100 Gold Street RFP Project Number #10975 Q&A #2 April 30, 2025

QUESTIONS AND ANSWERS¹

Tax Map

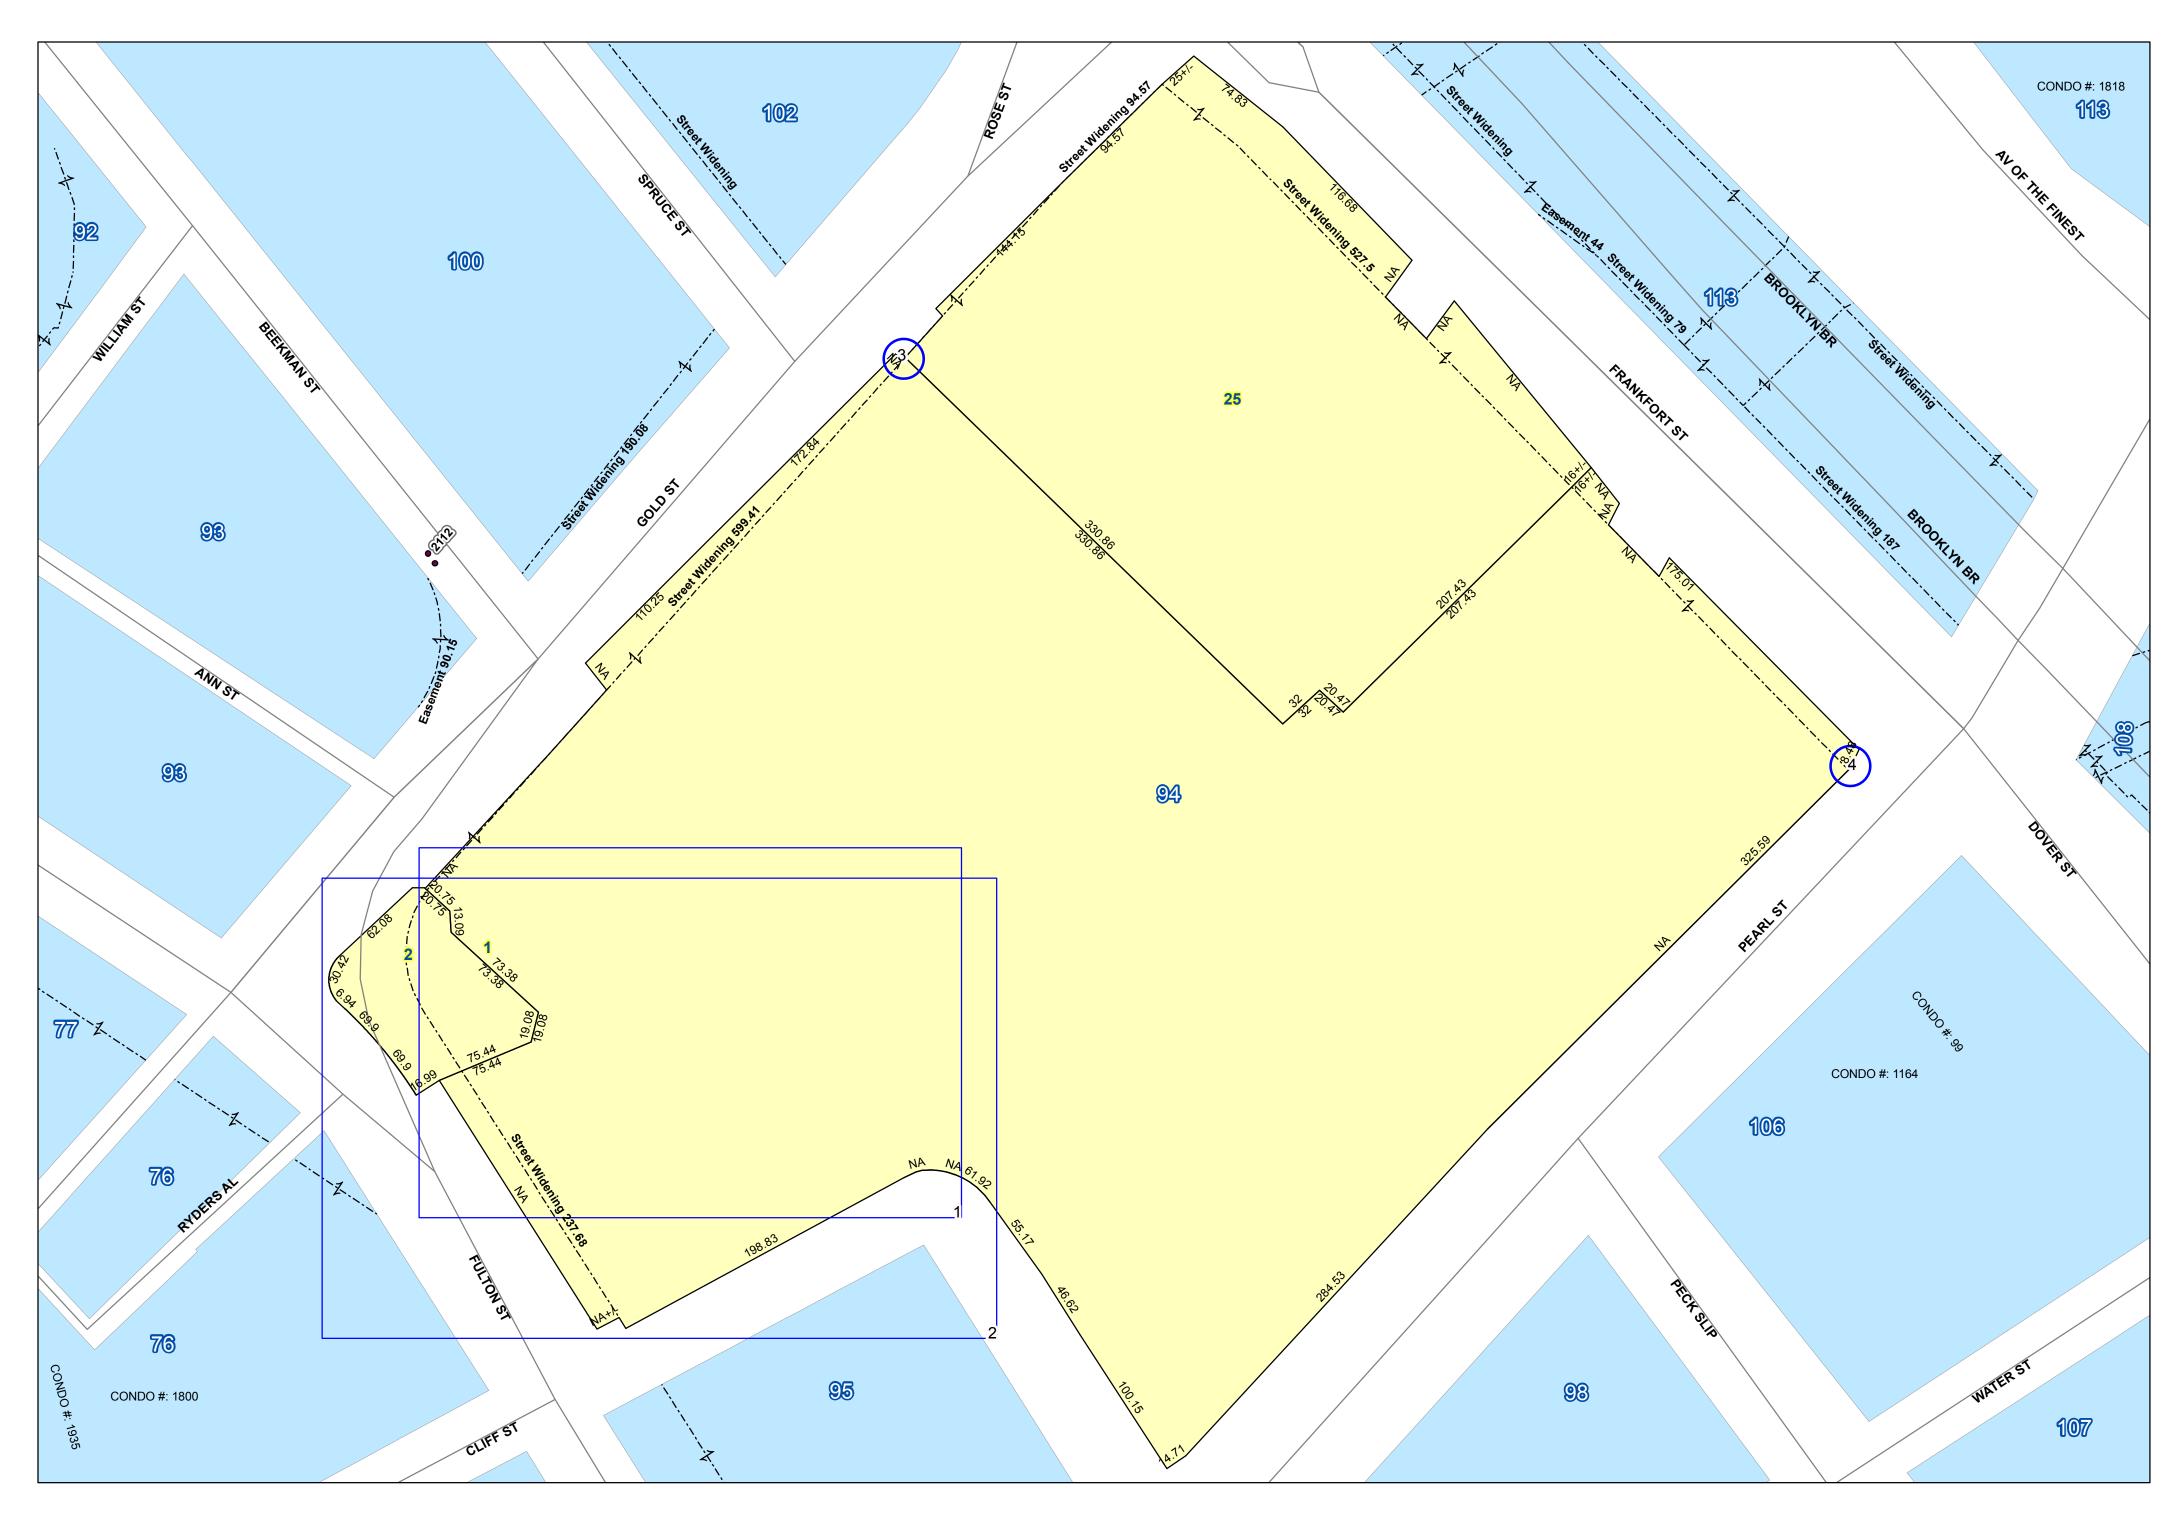
11. Is the existing building built to the lot line? Where is the lot line?

Attached is a digital tax map provided by the Department of Finance. Respondents are encouraged to conduct their own due diligence to determine the location of the building in relation to the lot line.

Sewer Map

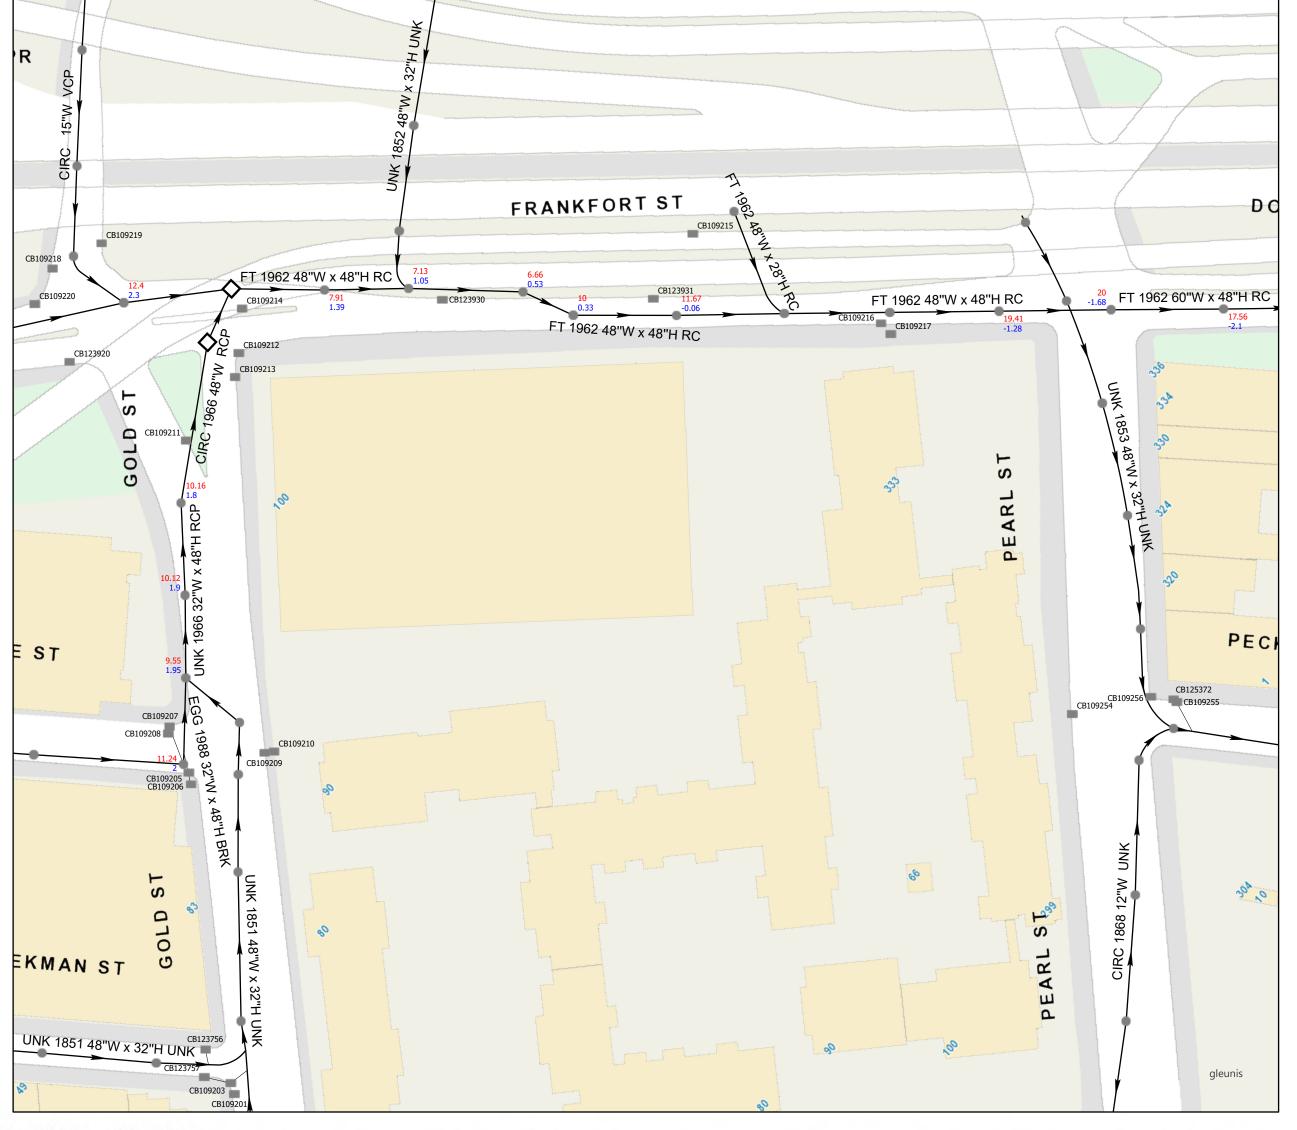
13. Can proposers assume that the future development can be built above the sewer easement?

18. Where are water and sewer connections located?

Water and sewer maps, provided by the New York City Department of Environmental Protection (DEP), are attached to the Q&A. Although there is a sewer easement, there is no mapped DEP infrastructure within the Site. Respondents are encouraged to conduct their own due diligence to determine the implications of the sewer easement.

The water and sewer maps are attached.
